BRIEFING DETAILS

BRIEFING DATE / TIME	Monday, 2 May 2022, 11.00am to 11.40am
LOCATION	Teleconference

PPSSWC-226 – Liverpool City Council – DA-143/2022 – 1382-1384 Camden Valley Way, Leppington – Construction of 93 dwellings including 67 x attached dwellings and 1 x secondary dwelling, 4 x semi-detached dwellings, and 7 x multi-dwelling housing developments (containing 3 x dwellings each) within approved lots 20 & 21 in DA-400/2018, associated earthworks, roads, stormwater infrastructure, and landscaping. Subdivision of the Site into 81 Torrens title lots, including 1 residue lot, and subsequent Strata subdivision of 7 x multi-dwelling housing developments and 1 x principal and secondary dwelling.

Figure 2: Example MDH layout with studio dwelling. GF (left) & FF (right)

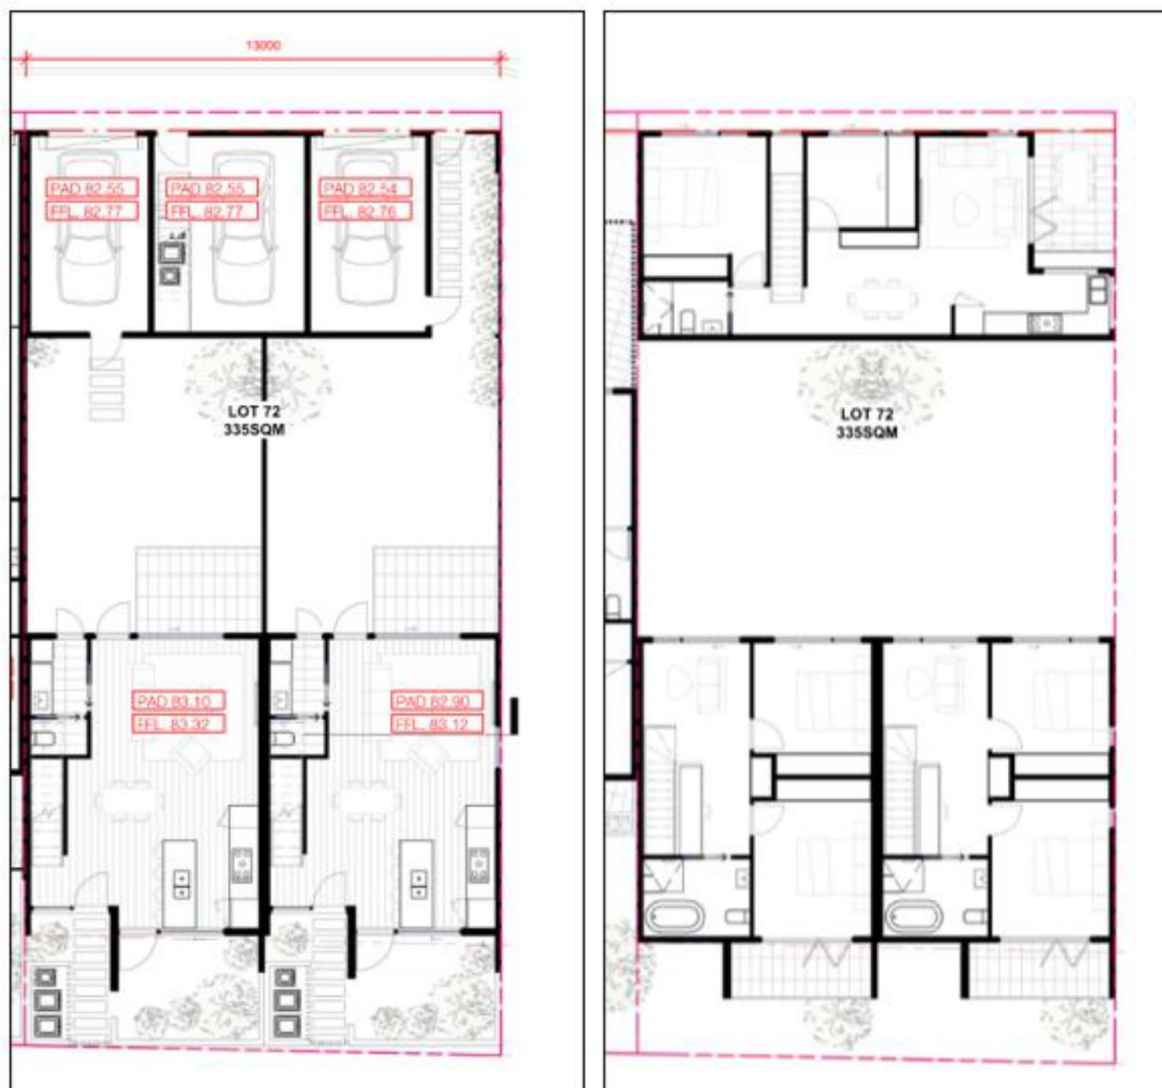
This sketch example is provided in the clause 4.6 request for one of those lots measuring 335 m2 in area:

The Panel requires the assessment report to explain carefully how clause 4.1AB of the Growth Centres SEPP applies to the different housing types proposed in the DA including the multi dwelling housing taking into account clauses 4.1AF and 4.1AC in terms of minimum lot sizes, noting that there does not appear to be a clause similar to clause 4.1(4) of the standard instrument in the Growth Centres SEPP.

- The Panel also queries whether clause 4.1AF applies if the form of housing proposed is not a “dwelling house”, noting that the multi dwelling housing would not meet that description.
- Notably, the definition of “multi dwelling housing” reads:

- The applicant’s justification for the multi-unit housing form of development as the panel presently understands it is that locating a separate attic apartment across the rear of both terraces delivers a better planning outcome than restricting the unit to being located above one of the terraces only.
- It is not immediately clear how the discussion of that form of development proposed (and its contribution to diversity of housing) as presented in the clause 4.6 request relates to the fact that 6 of the lots upon which three dwellings are proposed to be located are below the minimum lot size.

- There might also be amenity and acoustic issues arising from the proposed housing form, such as that the only windows and open space of the attic apartment present to a rear service lane with garage doors on both sides with no landscaping, and the associated noise canyoning effect. The acoustic engineer might be asked to comment. In Zones 6 & 7 it seems all windows (both bedroom and living room) would face the windows of the attic apartment opposite, albeit with the separation of the lane.
